**ANALYSIS OF NICHE STUDIES AND DEVELOPMENT
OF BASES FOR TOTAL-SYSTEM PERFORMANCE
ASSESSMENT SEEPAGE PARAMETERS**

**Nuclear Regulatory Commission
Contract NRC-02-97-009**

**Center for Nuclear Waste Regulatory Analyses
San Antonio, Texas**

This report provides an independent technical review of field studies and models of water seepage into waste emplacement drifts, niches, or alcoves conducted by the U.S. Department of Energy (DOE) for assessing performance assessment (PA) of Yucca Mountain (YM), Nevada, as a potential geological repository for high-level nuclear waste. Seepage into drifts is controlled by processes with a high degree of variability and uncertainty including shallow infiltration of precipitation, deep percolation through and lateral diversion along nonwelded units of the Paintbrush Tuff, preferential flow and fast pathways through a heterogeneous network of fractures and faults, and a potential capillary barrier at the drift wall. Once inside the emplacement drift, water must enter a breach in a waste package (WP) to contact and dissolve spent nuclear fuel. This report focuses on the nature of deep percolation through fractured rock of the Topopah Spring Tuff (T

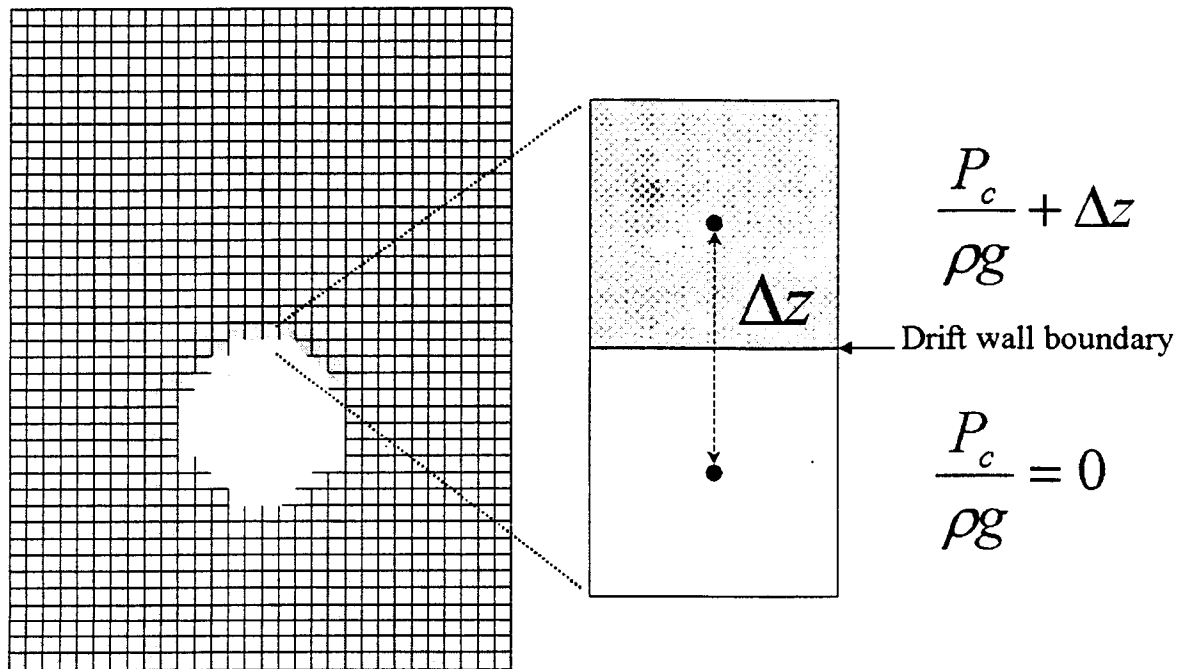
Despite incorporating comments from the DSPR, the proposed SCM still has significant shortcomings that render it inadequate to address or to bound the potential seepage volume and fraction of affected WPs. The SCM is based on small-scale (0.65 m), short-term (a few hours), high-volume liquid-release tests within the zone dried out by ventilation in the ESF. The SCM does not account for

moisture lost to evaporation during the field test, nor does it model matrix imbibition explicitly. Instead, the effect of matrix imbibition is reflected in an effective porosity obtained through inverse modeling. Nodal connections between the mesh elements of the SCM and the niche ceiling boundary are arbitrarily set to 0.05 m. Model calculated seepage into drifts is sensitive to the distance between the drift wall boundary and the node of the element immediately above.¹ Seepage flux will cross the drift wall boundary when saturation at a point just inside the rock formation reaches 1.0. Defining the drift crown as a reference elevation for convenience, this occurs when capillary pressure and total potential in the rock at the drift crown are zero. By connecting the mesh element node to the boundary with a nonzero vertical component, a gravity term equal to this vertical distance is added to the total potential (figure 2-2). Thus, seepage will cross the drift wall boundary when the pressure immediately inside the rock formation plus this gravitational term slightly exceeds the pressure inside the drift. This results in flux crossing the drift wall boundary at model saturation in the rock less than 1.0. Consequently, an α parameter determined by inverse modeling to match test data of seepage flux with a nonzero vertical connection distance between the drift wall boundary and the mesh element node is merely a fitting parameter that has no physical meaning or relationship to fracture characteristics such as aperture. Treating α as a fitting parameter to be adjusted through inverse modeling may still produce acceptable results but probably only if the inverse calibration is to data representing conditions expected in the repository following the thermal period. The α parameter calibrated in this manner, however, is specific to the grid used for the inverse modeling.

The SCM is based on the conceptual model of lateral flow diversion due to capillarity. The lowest seepage threshold obtained from the SCM calibrated to liquid release data was approximately 250 mm/yr. According to the theoretical model of Philip et al. (1989), seepage threshold is inversely proportional to both the α parameter and the cavity size. Using Philip's theoretical model, a cylindrical cavity of radius 2.0 m in a porous media continuum characterized by a exponential relative hydraulic conductivity α parameter of 0.015 Pa^{-1} and permeability of $2.5 \times 10^{-13} \text{ m}^2$ would have a seepage threshold of 260 mm/yr. Reducing the cylindrical cavity radius to 0.25 m in the same porous media continuum increases the seepage threshold to 2,000 mm/yr. For a spherical cavity of radius 0.25 m in this porous media continuum the seepage threshold is even higher, approaching 4,000 mm/yr. These numbers are not exact nor do they necessarily apply to YM. They are intended only to illustrate that the SCM calibrated to liquid-release tests implies that water could never enter cavities the size of lithophysae. There is, however, abundant evidence that water has infiltrated into lithophysal cavities from deposits of secondary minerals. Evidence of seepage flux based secondary mineralization is discussed in chapter 4.
